Amendment No. 16
License No. DPR-22

ATTACHMENT TO LICENSE AMENDMENT NO. 16

SAFETY EVALUATION BY THE OFFICE OF NUCLEAR REACTOR REGULATION

MONTICELLO NUCLEAR GENERATING PLANT

FIGURE 6.1.1 NSP CORPORATION ORGANIZATION RELATIONSHIP TO ON-SITE OPERATING ORGANIZATION

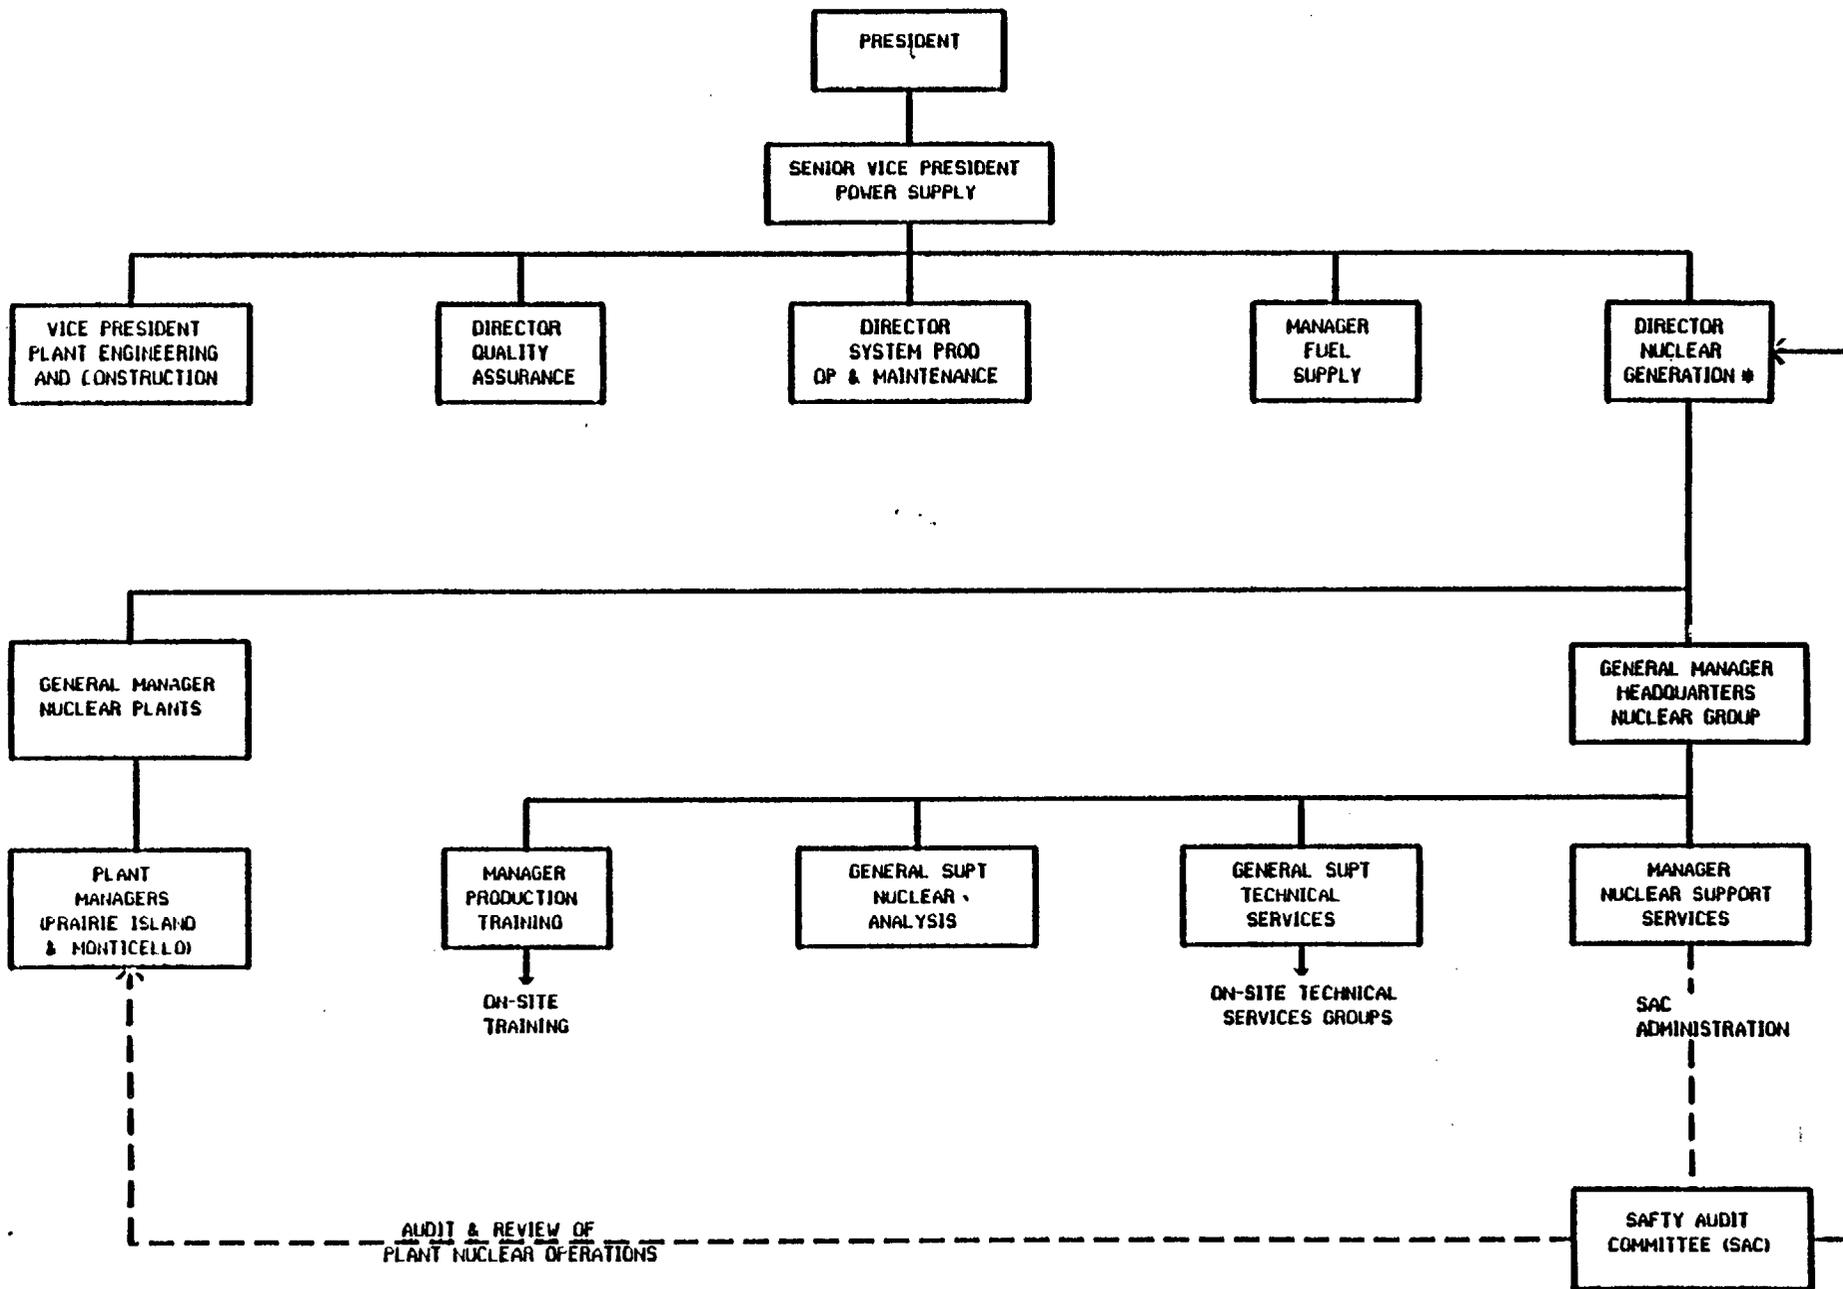
To reflect the recent organizational changes, the licensee has proposed to update the NSP corporate organization chart TS Figure 6.1.1 and specifies "Director, Nuclear Generation" in place of "Vice President Power Production" and "Director of Quality Assurance" in place of "General Superintendent of Operational QA". This title change to "Director, Nuclear Generation" has also been reflected in TS 6.2.A.6.c, 6.2.A.7, and 6.2.A.8. To maintain consistency, the NRC staff changed TS 6.2.A.1.b, as discussed with and agreed to, by the licensee.

FIGURE 6.1.2 MONTICELLO NUCLEAR GENERATING PLANT FUNCTIONAL ORGANIZATION FOR ON-SITE OPERATING GROUP

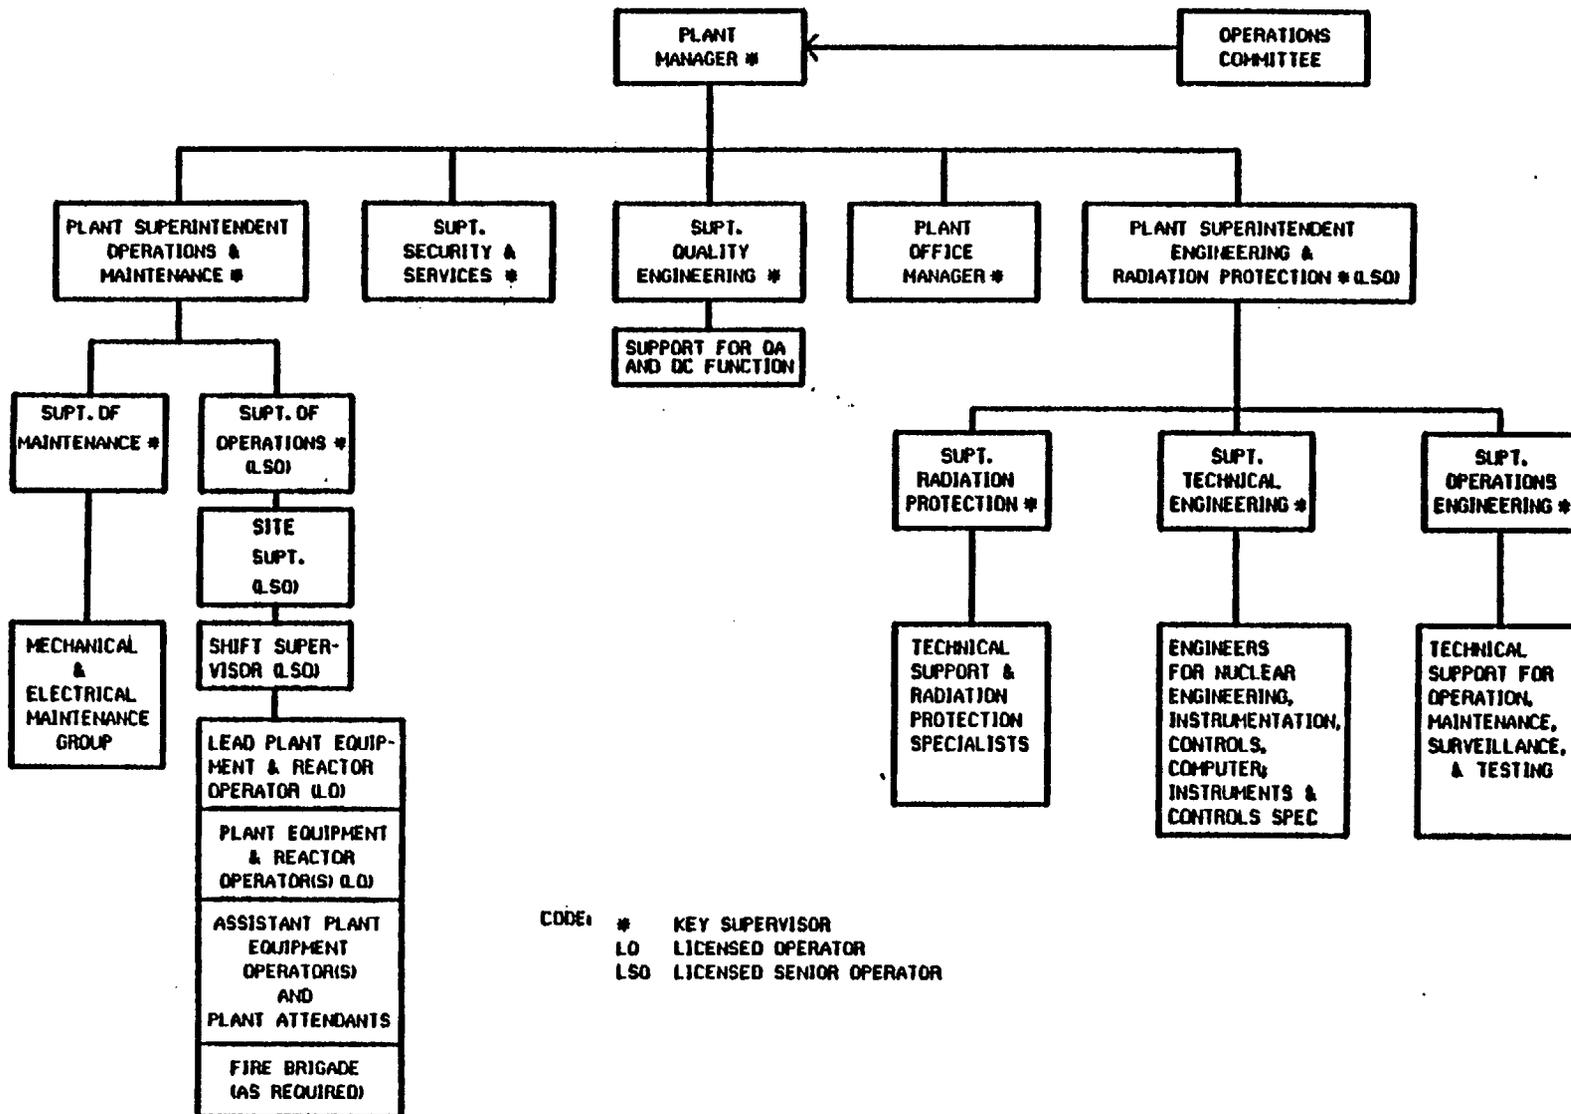
The licensee has also updated the Monticello On-Site chart, TS Figure 6.1.2, and deleted the position of Training Supervisor, who now reports to line management as the Manager of the new Production Training Department. Also, a new position of Site Superintendent has been added who is a licensed senior operator.
